RE: Biological Mitigation Proposal ("Mitigated Ivanpah 3")
Ivanpah Solar Electric Generating System (07-AFC-5)

Biological Mitigation Proposal ("Mitigated Ivanpah 3")

Submitted to the
Bureau of Land Management and the
California Energy Commission

Figure 2-1
Ivanpah Site Plan
 Ivanpah Solar Electric Generating System
 CH2MHILL

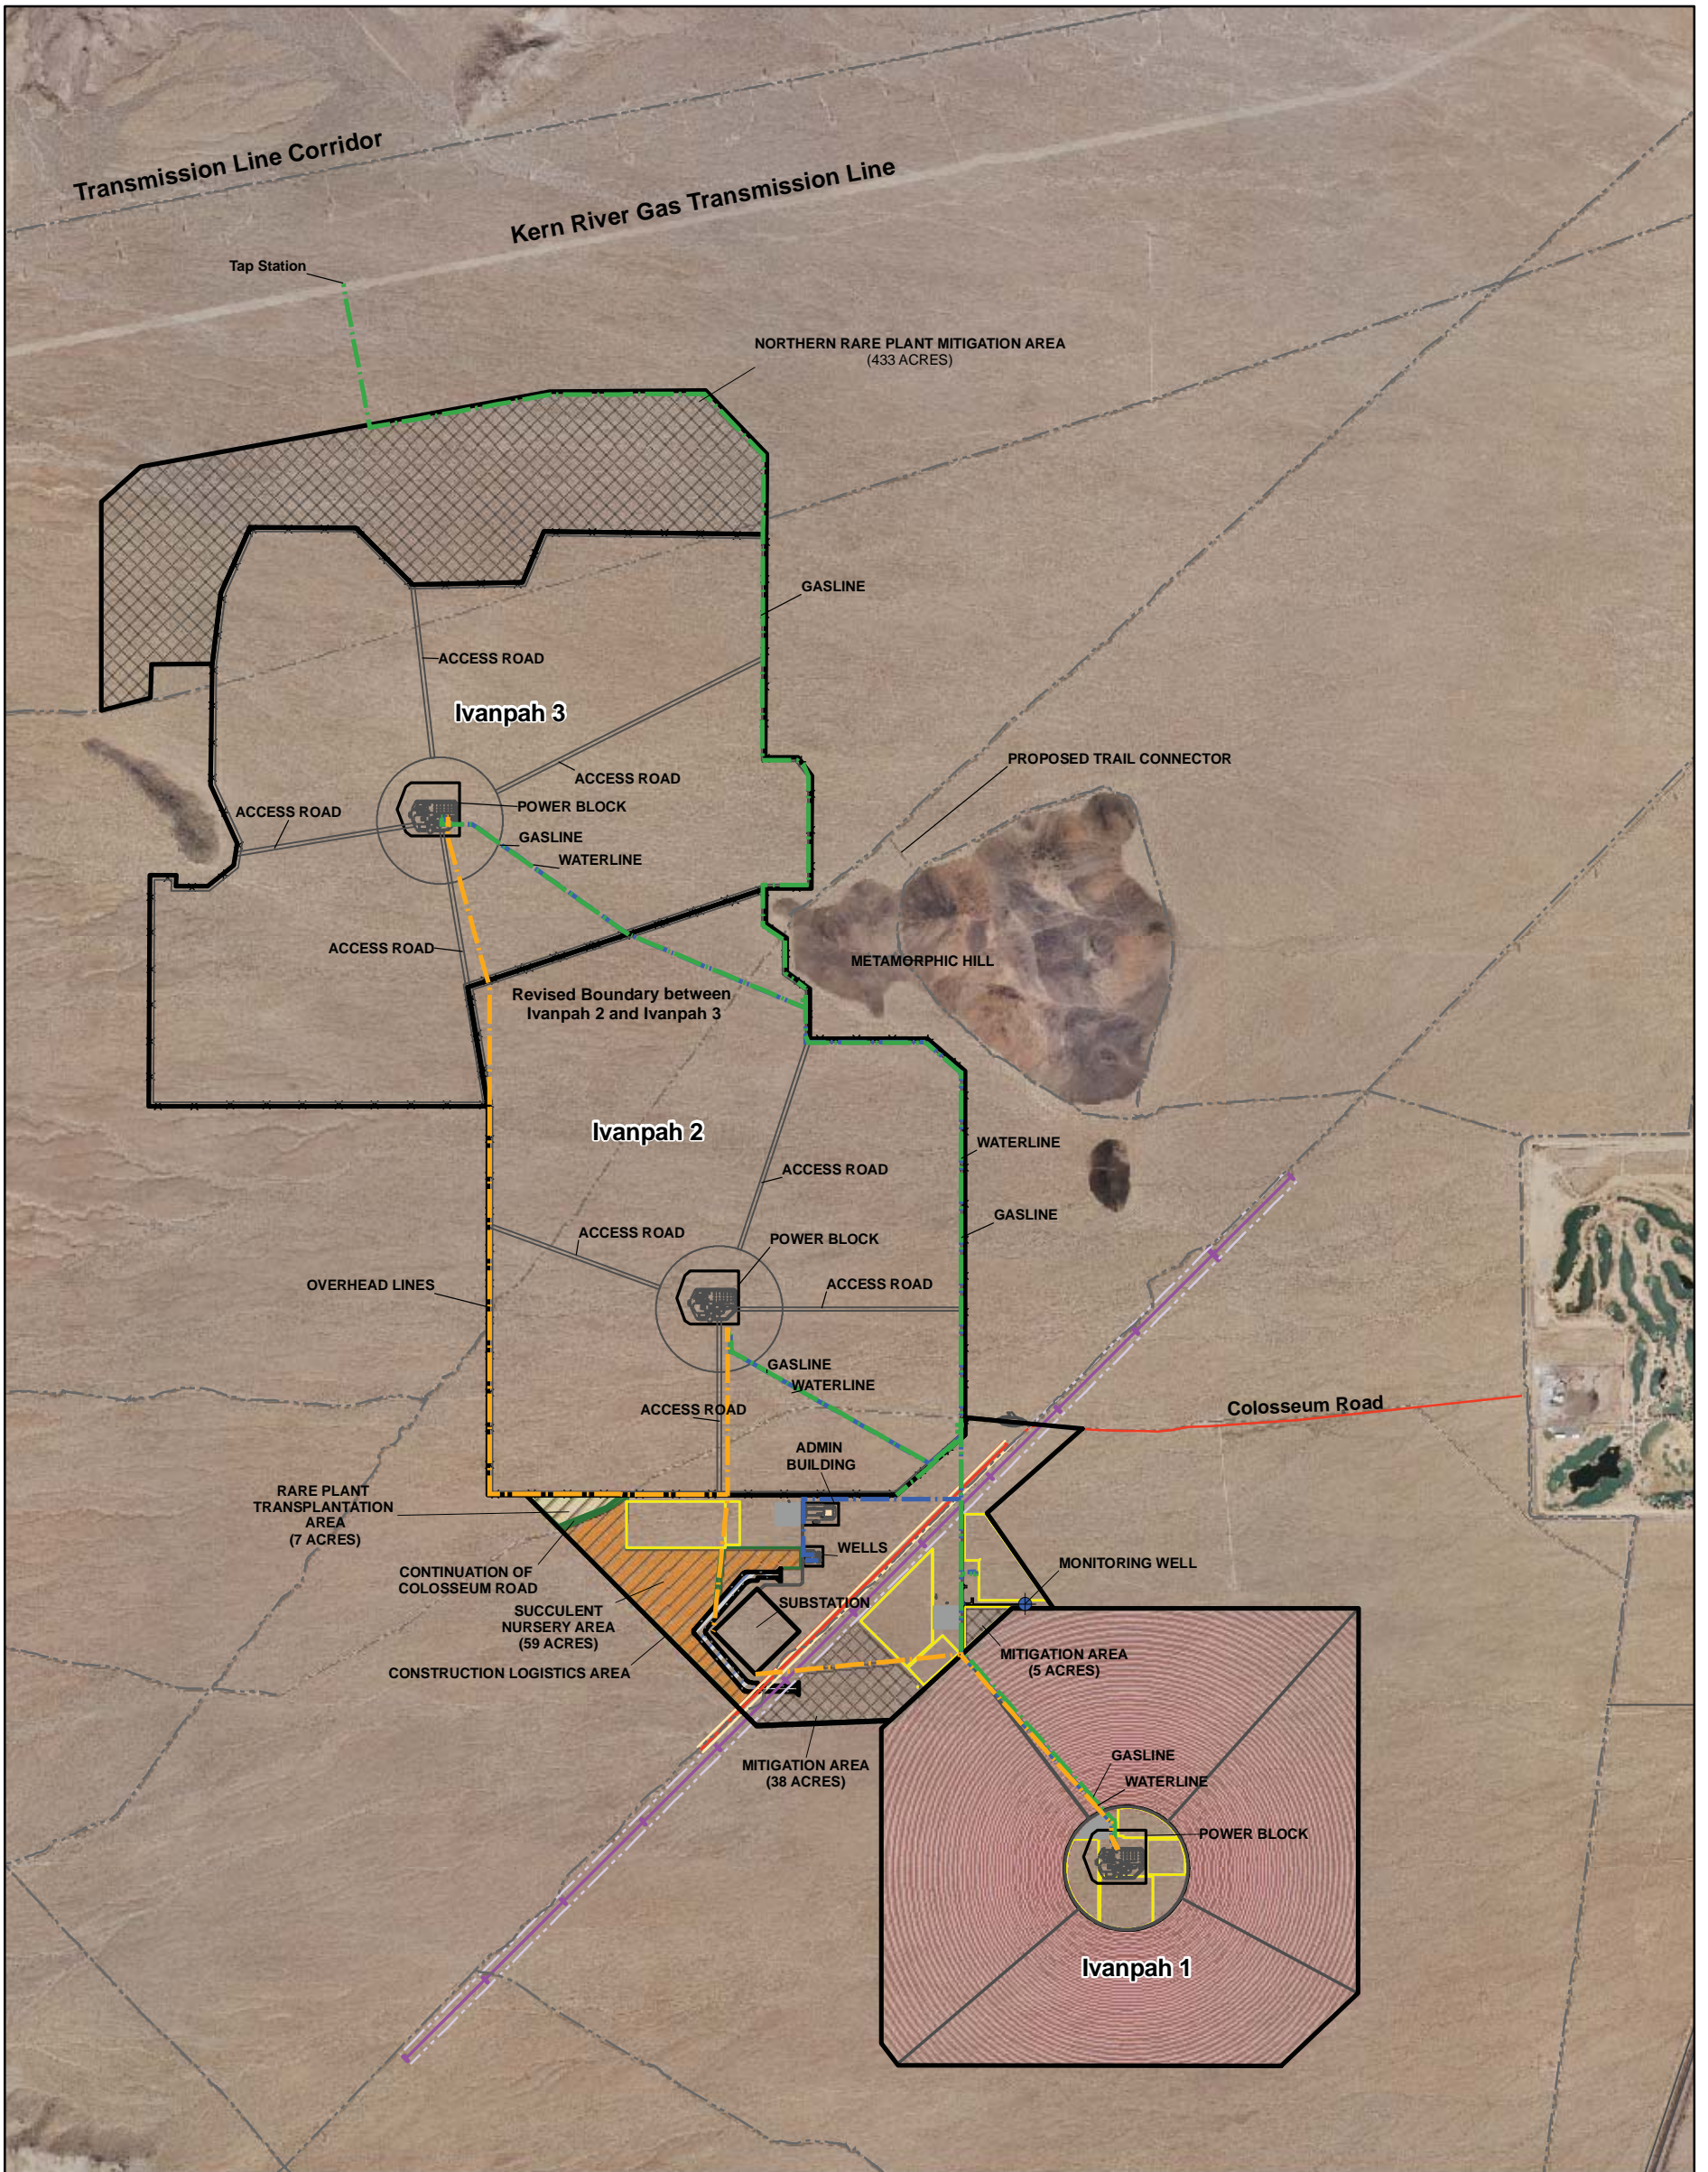
As the project moves into detailed design, some of the structures within the CLA have been moved and areas needed for construction have been reduced. The proposed CLA arrangement is shown in Figure 2-3. This arrangement would remove about 109 acres of the 377-acre CLA from construction use, avoiding rare plants located in those areas and setting aside that area for use as the plant nursery for relocation of salvaged cacti and rare plants.

The reduced footprint associated with Mitigated Ivanpah 3 and the reduction of the acreage of the CLA are both substantial: 433 acres reduced at Ivanpah 3 and 109 acres removed from construction in the CLA for a total reduction of approximately 542 acres. The 542-acre reduction represents an approximately 12 percent reduction in acreage of the entire 4,062-acre project footprint. As described in the AFC, the initial Plan of Development was for 7,040 acres. With the Mitigated Ivanpah 3 arrangement, the 3,520-acre Mitigated Ivanpah 3 project would be half the size of the original 7,040-acre proposed property boundary.

FIGURE 2-2
ARTIST RENDERING OF THE
BIOLOGICAL MITIGATION PROPOSAL
IVANPAH SOLAR ELECTRIC GENERATING SYSTEM

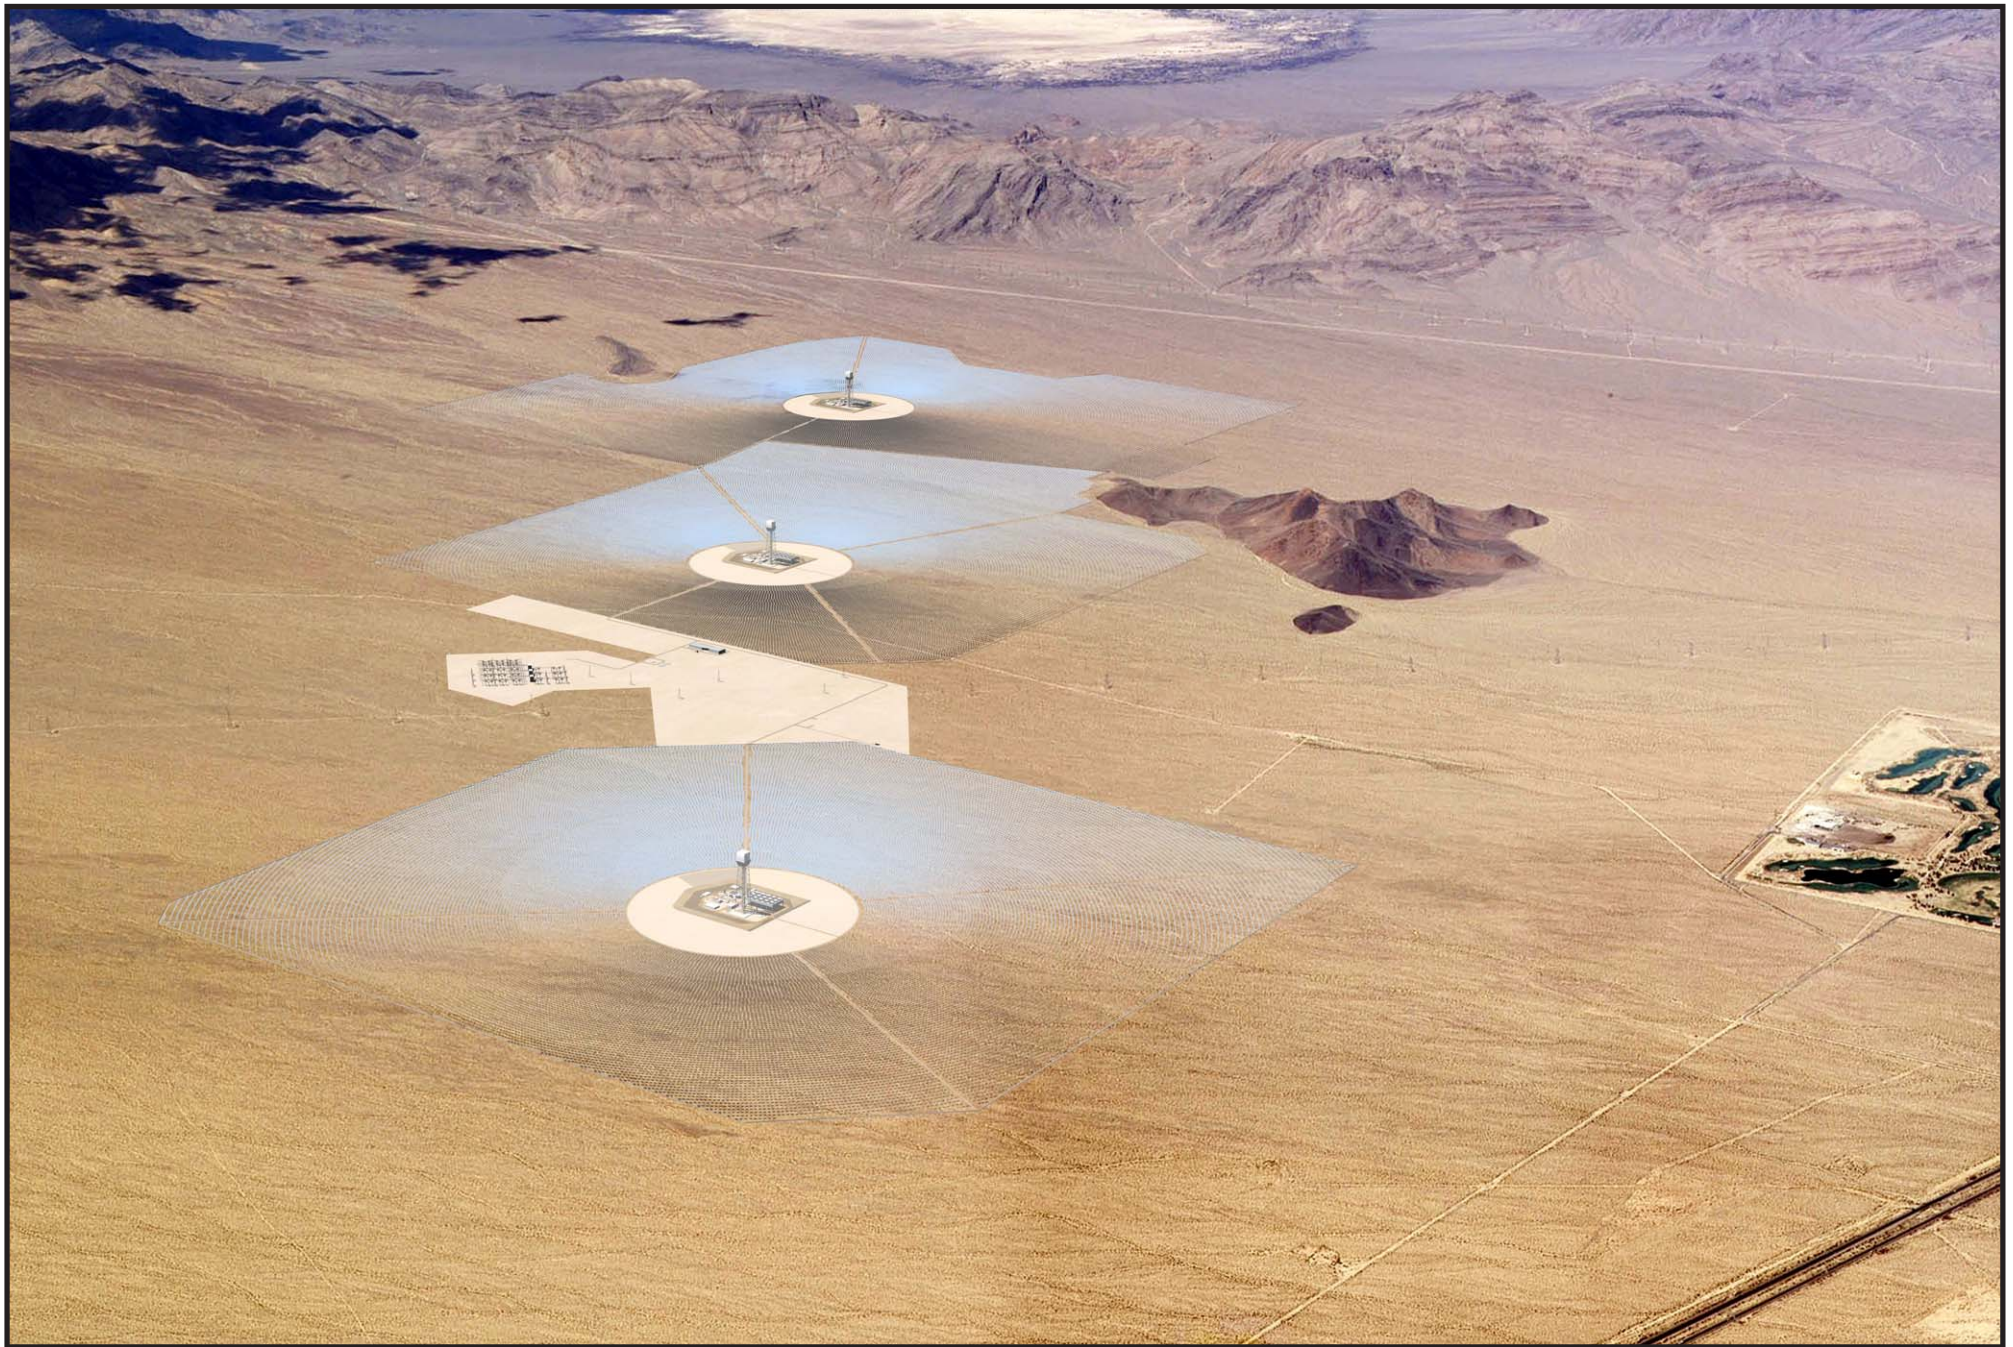
The Applicant's proposal of a Mitigated Ivanpah 3 alternative attempts to accommodate Commission Staff's suggestion, and those of some Intervenors, to reduce the botany and other biological resource impacts in Ivanpah 3 by avoiding construction in the northern-most section of the site, as well as to reduce botany impacts within the Construction Logistics Area (CLA). This Biological Mitigation Proposal includes the following key changes to the project description:

- Removes approximately 433 acres from the northern portion of the Ivanpah 3 and more than 40,000 heliostats
- Reduces the number of power towers in Ivanpah 3 from five to one, and of the entire Ivanpah project from seven to three
- Relocates the power block for Ivanpah 3
- Realigns the boundary between Ivanpah 2 and 3 and the heliostat fields
- Realigns some roads and utilities within the project footprint
- Relocates the administration building and water supply wells within the Construction Logistics Area (CLA)
- Removes approximately 109 acres from construction use within the CLA

Figure 3-1
Desert Tortoise Locations and New Ivanpah Layout
Ivanpah Solar Electric Generating System

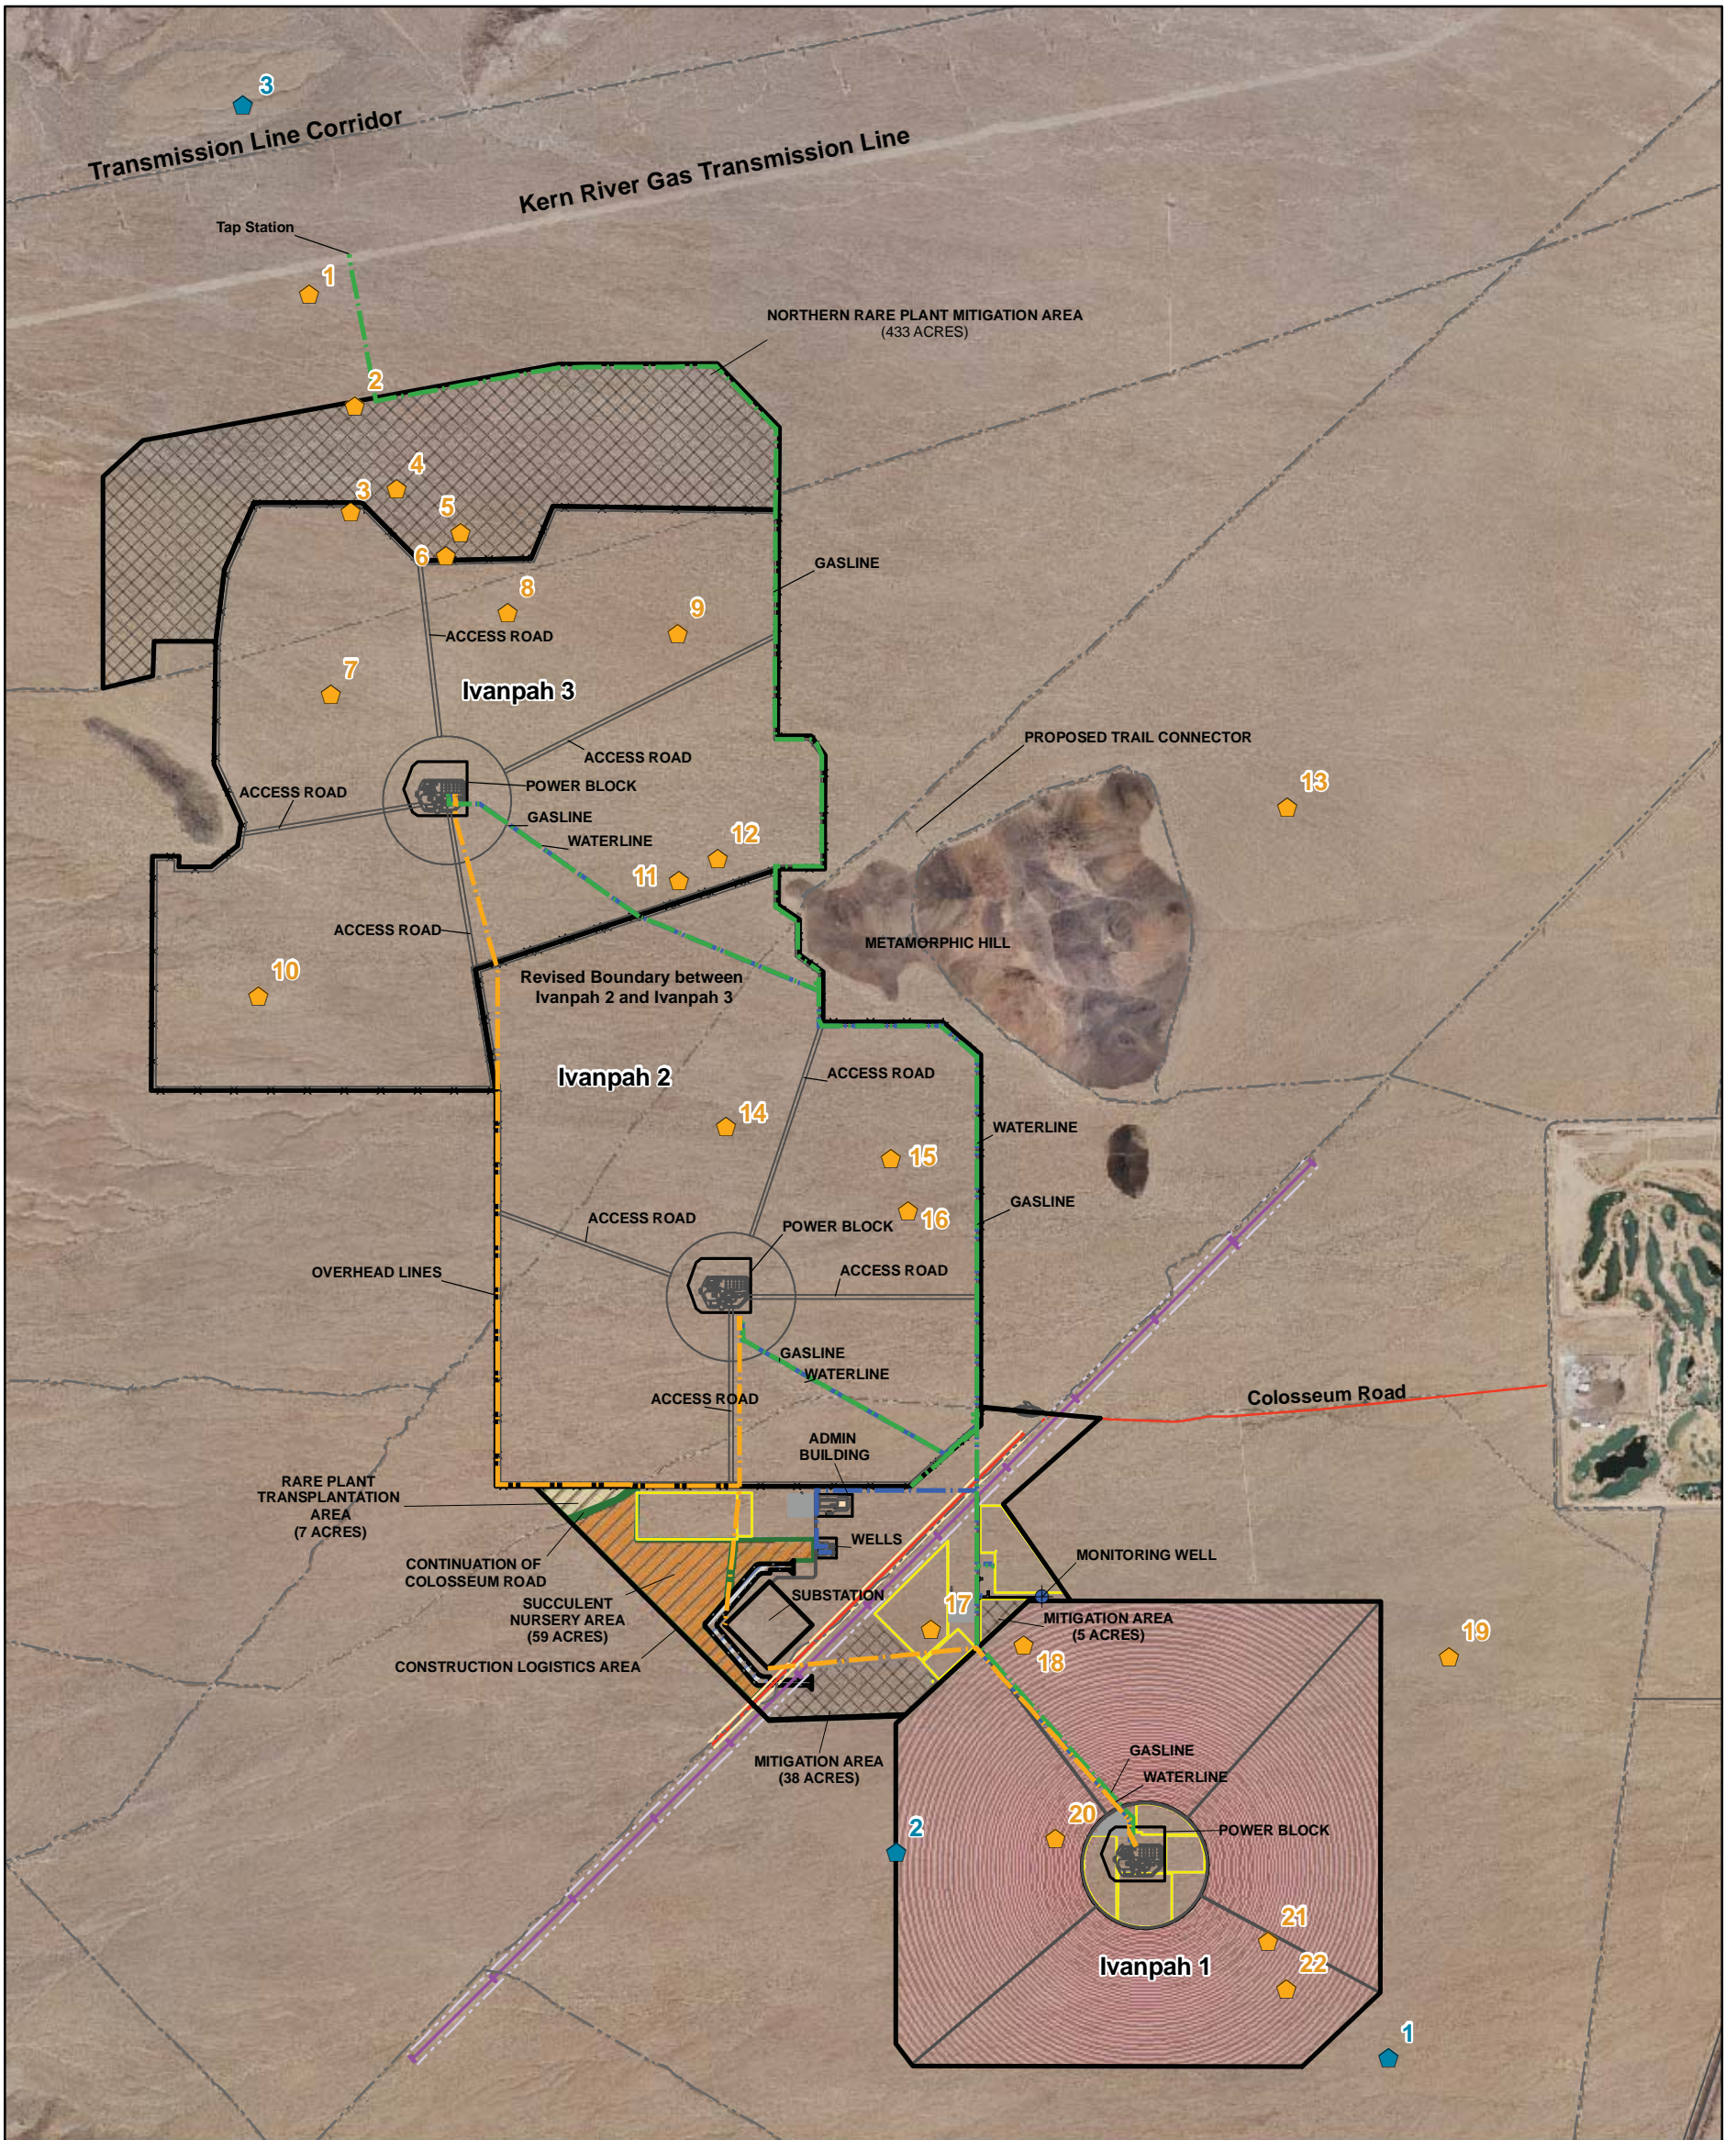
The Mitigated Ivanpah 3 configuration would benefit the desert tortoise by avoiding long-term impacts to 433 acres of habitat, and provide additional area for tortoise relocation within their home range. These 433 acres of habitat would remain available to tortoises for foraging, cover, and other life cycle requirements. While it is unknown how many tortoises would be in this area at the time of construction, 3 of the 20 live tortoises observed within the project boundary during the 2007 and 2008 surveys would be avoided resulting in the need to relocate about 15 percent fewer tortoises (see Figure 3-1). At a minimum, 17 existing burrows in this area would also be preserved.
